## ANSWERS TO QUESTIONS ON NOTICE

- 1. Continuation of my answer to Mr Vietch's question – page 20 of transcript – What do you think was the adequacy of consideration around alternative options and the measuring of the impact on those two sites?**

## **2. Continuation of my answer to Ms Boyd's question at page 22 of transcript**

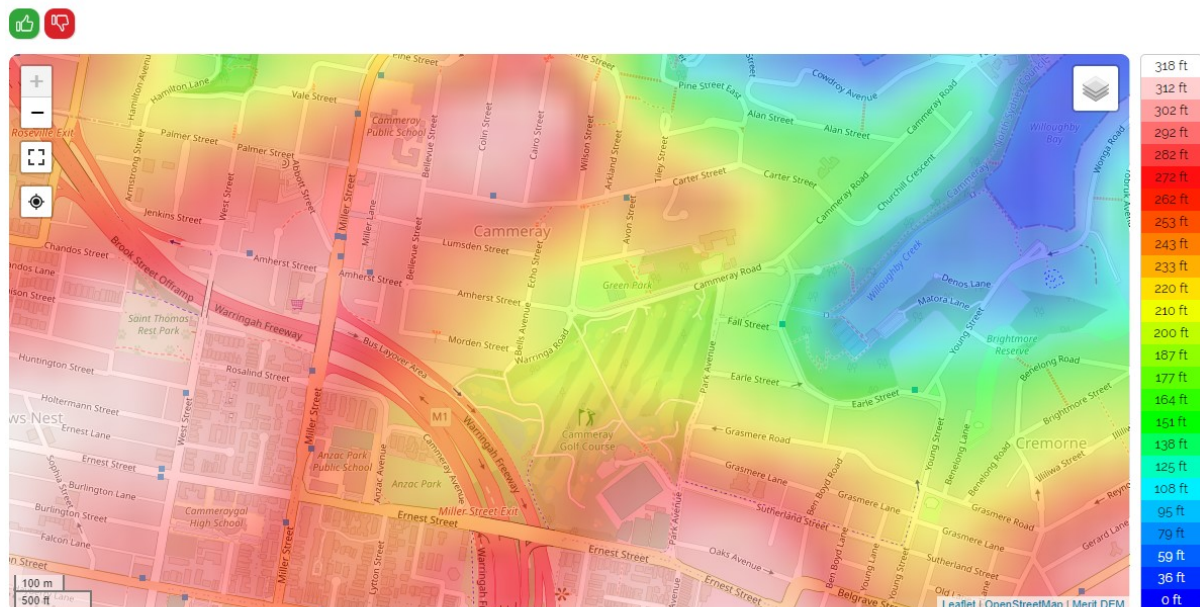
As illustrated by the screenshot below, the six sub-areas considered by the Jacobs Report, are located towards the top of a rim, with the golf course below them and any groundwater from the sites would be expected to migrate in a generally north-easterly direction to Willoughby Creek which then discharges into the waters of Willoughby Bay via Primrose Park.

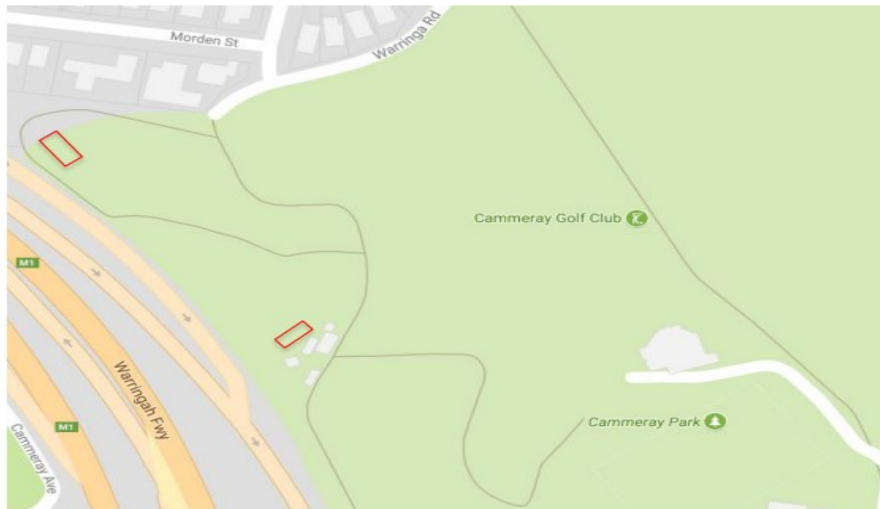
*It is Jacobs understanding that the statement of "Known contamination" for this area (from the EIS) is based on the Western Harbour Tunnel and Beaches Link - Contamination Factual Report, AECOM and Coffey, 2018. The reported contamination was related to Polycyclic Aromatic Hydrocarbons (at two locations) and asbestos containing materials (at one location). However, the location of these sample points, in relation to the investigation area, (i.e. Cammeray Golf Course) being assessed by Jacobs, was not clear. Therefore, it is not known if these sample points are located within the investigation area (the subject of this report), and the data was excluded.*

This statement is contrary to the EIS which states that the asbestos was found at a borehole in Cammeray Golf Course (B340\_0.05-0.25) - see Appendix M, section 4.4.4, at page 65 and the last dot point on page 64.

The precise location of the borehole within Cammeray Golf Course would be expected to be precisely recorded and this information would be available to Jacobs via TfNSW.

It also appears that the location of B340 within Cammeray Golf Course could have been established by a simple internet search showing the intended location of the geotechnical investigations carried out in 2017, see: <https://roads-waterways.transport.nsw.gov.au/projects/01documents/western-harbour-tunnel-beaches-link/whtbl-cammeray-golf-club-geotech-b337-b338-b339-b340-2017-07.pdf>
